**DTB**

Date: April 23, 2009  
 Order No.: S-B-03.30/08i  
 Supersedes: S-B-03.30/08h dated October 24, 2008  
 Group: 03

**SUBJECT:** **Model 164.156/172/186/871/886**  
**Model 171.454/456**  
**Model 203.052/054/056/087/092**  
**Model 204.054/056/081/987**  
**Model 209.356/372/456/472**  
**Model 211.056/072/087/090/256/287**  
**Model 216.371/386**  
**Model 219.372**  
**Model 221.171/186**  
**Model 230.471**  
**Model 251.156/165**  
**Equipped with M272 or M273 Engine**  
**Check Engine Light On / Fault Codes Current and/or Stored in ME-SFI Control Module / Oil Leaking at Camshaft Adjustment Solenoid**

Figure 1 – Damaged/worn S-B-03.30/08a

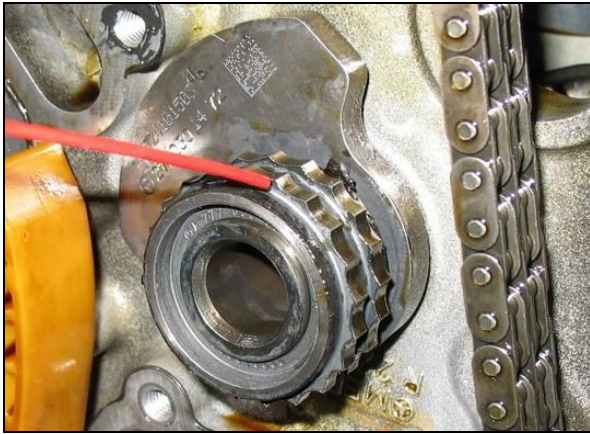
- a) Perform a visual inspection for any wear of the teeth (damage profile) on the sprocket of the balance shaft (M272) or of the guide (idler) gear for timing chain (M273) by removing the timing case cover on the engine. Refer to WIS instructions AR01.40-P-8000\* (\* - applies to a specific model designation e.g. AR01.40-P-8000SX – models 221, 216). Ensure the use of the Special Tool W001 589 81 09 00 when removing / installing timing case cover.

**i** **Note:** Refer to Figure 1 through 3 for examples of damaged / worn sprocket profile. Refer to Figure 4 for example of a new gear (for comparison).

- b) Only if worn (sprocket teeth profile damaged), replace the balance shaft on engine M272 or replace the guide (idler) gear of the chain drive on engine M273 as per WIS instructions AR03.20-P-1000\* (\* - applies to a specific model designation e.g. AR03.20-P-1000VA – model 171).

Figure 5

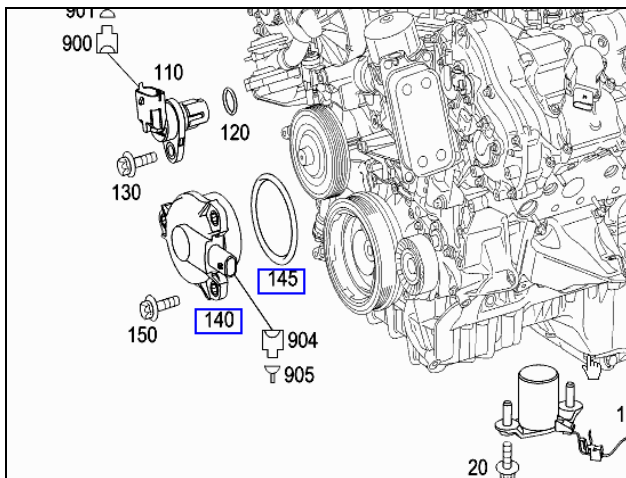
**Fault Scenario 3:** Camshaft adjustment solenoid is leaking oil, and no Fault Codes are current or stored in the ME Control Module. Determine the cause of the leak. The solenoid can be leaking from under the sealing ring or through the harness connector.

- a) If the leak appears to be between the solenoid and the cylinder head replace solenoid sealing ring (Figure 5, 145).
- b) If the leak is from the electrical connector, replace the solenoid (Figure 5, 140).
